APPLICATION NO.	FILING DATE	FIRST NAMED INVENTOR	ATTORNEY DOCKET NO.	CONFIRMATION NO.
10/780,082	02/17/2004	Michael L. O'Banion	0275Y-625COD	9514

Office Action Summary	Application No.	Applicant(s)	
	10/780,082	O'BANION ET AL.	
	Examiner	Art Unit	
	Katherine W. Mitchell	3677

DETAILED ACTION

Fig. 3(A)**Fig. 3(B)****Fig. 2****Fig. 3(C)**

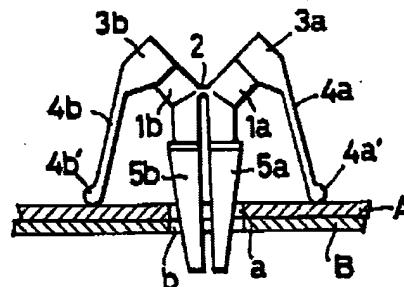
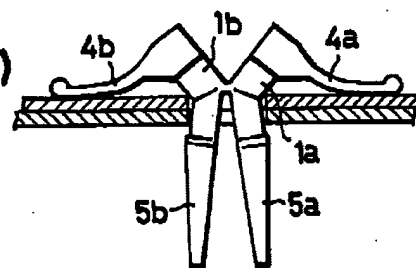
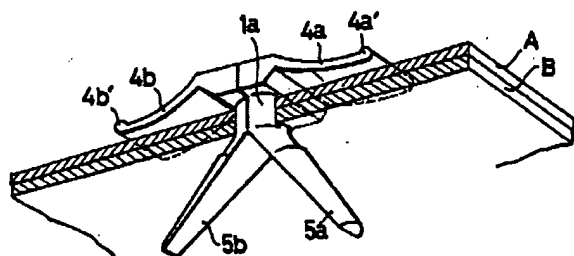
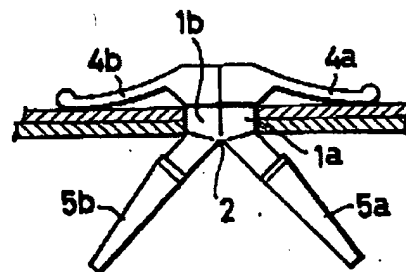
4. Claims 85-87,90-91, 104-106, and 109-110 are rejected under 35 U.S.C. 102(b) as being anticipated by Tanaka USP 4112815. Tanaka teaches in Figs 2 and 3(A) - 3(C) a nail capable of fastening framing members together, comprising

- First member with elongated segment (5b), flange segment (formed by combination 3b,4b,4b'), and angular segment (1b) between elongated and flange segments that is not parallel to either the elongated or flange segments
- Second member with elongated segment (5a), flange segment (formed by combination 3a,4a,4a'), and angular segment (1a) between elongated and flange segments that is not parallel to either the elongated or flange segments (see below)

- Wherein said elongated segments 5a,5b are substantially parallel to each other

and form a tip configured to penetrate adjacent framing members prior to passing through said framing members (Fig 3(A)) and said first and second members are configured to receive a driving force that drives a portion of said 1st and 2nd members through the framing members (col 1 lines 48-67 and col 3 lines 20-col 4 line 29), said driving causes angular segments of 1st and 2nd members to move toward one another and said elongated segments to move away from each other thereby fastening said framing members (A,B) together between said elongated segments and said flange segments (Fig 3(C), and said flange segments are separate and spaced apart prior to said angular segments moving toward one another (Fig 3A, 3B).

Re claim 86: Looking at Fig 3(C), when the fastener is in the fully inserted position, the flanges are perpendicular to the angular segments.

Re claim 87: "Coupling" does not require physical joining but can include mating or pairing, and at least the very ends of the elongated segments are physically coupled at the hinge point 2 in Fig 3(A).

Re claims 90,91: At least one of -- said angular segments or said flange

segments-- of said first and second members is configured to receive said driving force, per Figs 3(A)-3(C) and col 1 lines 48-67 and col 3 lines 20-col 4 line 29.

Re claims 104-105, 109-110: The method is taught in Figs 3(A)-3(C) and col 1 lines 48-67 and col 3 lines 20-col 4 line 29. Note that the method does not require piercing. A force transmitting device of some kind is inherent - the device gets force through the panels/framing members. "Coupling" does not require physical joining but can include mating or pairing, and at least the very ends of the elongated segments are physically coupled at the hinge point 2.
